DECISION, CONDITIONS, FINDINGS OF FACT AND CONCLUSIONARY FINDINGS OF THE MCMINNVILLE HISTORIC LANDMARKS COMMITTEE FOR THE APPROVAL OF A NEW BUILDING AT 609, 611 AND 619 NE THIRD STREET WITHIN THE DOWNTOWN DESIGN AREA

DOCKET: DDR 2-22 (Downtown Design Review)

REQUEST: Approval of the exterior design of a proposed new five-story hotel with ground floor commercial, an underground parking garage and an active roof deck, to be constructed on a property located within the Downtown Design Overlay District

Basement – Underground Parking Structure

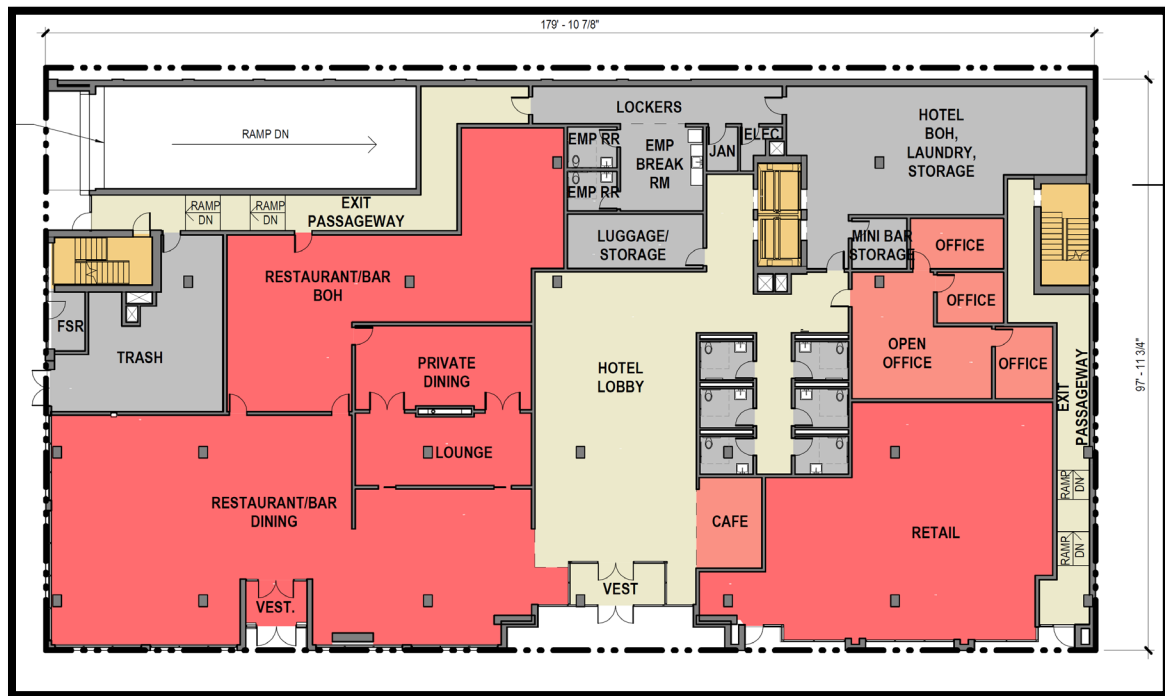
2. Provide detailed plans for the parking structure, email correspondence has been provided by the developers engineer mentioning a possible encroachment into the city right-of-way for the structure of the underground parking. This needs to be reviewed prior to permit issuance.

If approved, the following condition of approval would be necessary: Provide detailed plans for the parking structure, email correspondence has been provided by the developers engineer mentioning a possible encroachment into the city right-of-way for the structure of the underground parking. This needs to be reviewed prior to permit issuance.
